**From:** [Bob Cowlin](#)  
**To:** [BramfordtoTwinstead](#)  
**Subject:** RE: Examining Authority's Further Written Questions (ExQ2) CA2.4.1 Robert Arthur David Cowlin  
**Date:** 08 January 2024 14:57:08  
**Attachments:** [image007.png](#)  
[image014.jpg](#)  
[image006.png](#)  
[image009.jpg](#)  
[image011.png](#)  
[image013.png](#)  
[img20240108\\_14543953.pdf](#)

NATIONAL GRID  
(BRAMFORD TO TWINSTEAD)

Option Agreement Plan  
1 OF 1

PLAN ID: NG-BTNO-OPT-275-PLAN-1

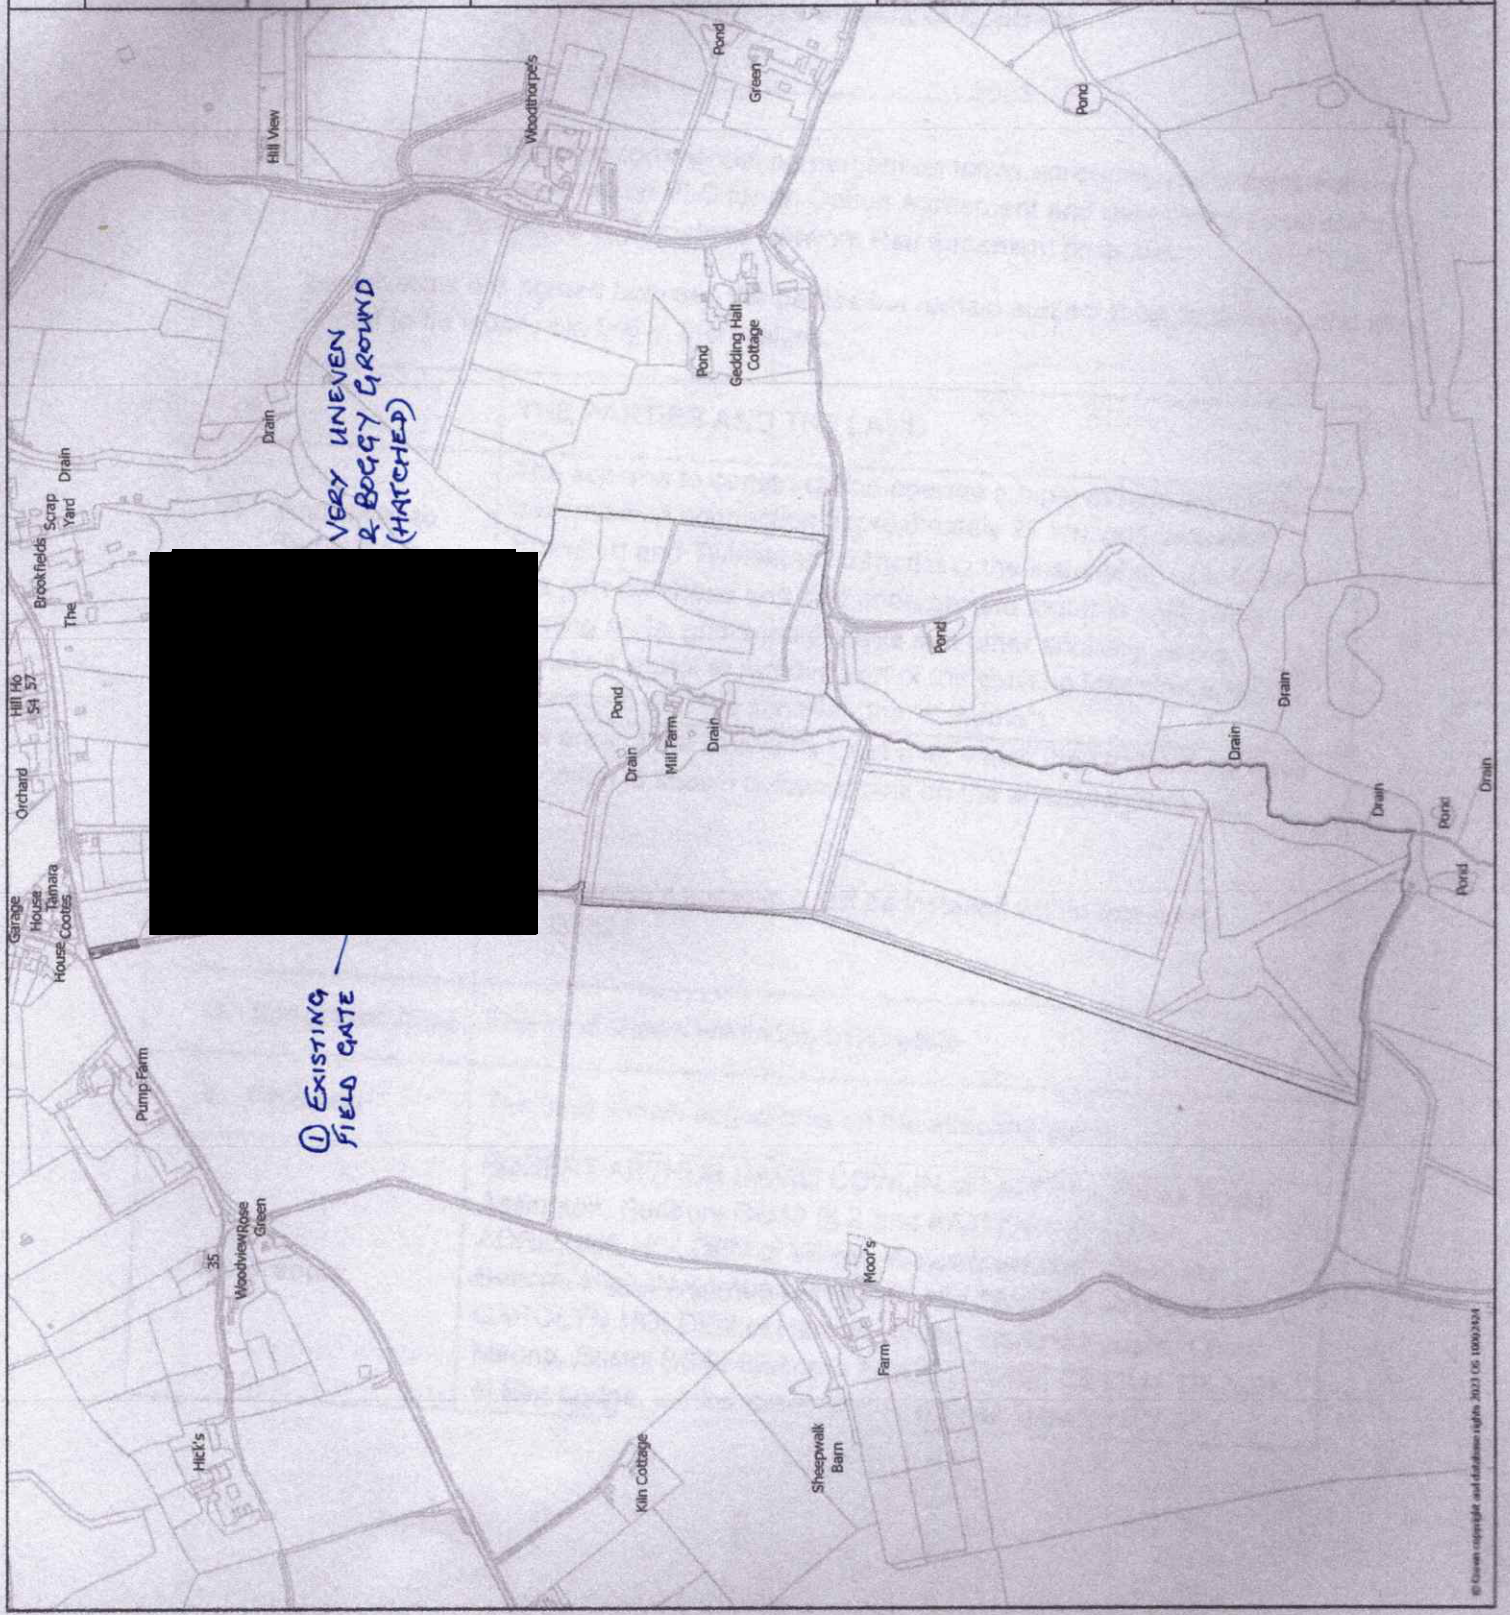
I object to them making a new break in my hedge when an existing field gate can be used (see Point 1 on attached plan). I object to their route to remove Pylon PCB 66 because that crosses very uneven and boggy ground (Point 2) and [REDACTED] when a more practical route exists through the horse paddocks to the north.

VERY UNEVEN  
& BOGGY GROUND  
(HATCHED)

① EXISTING  
FIELD GATE
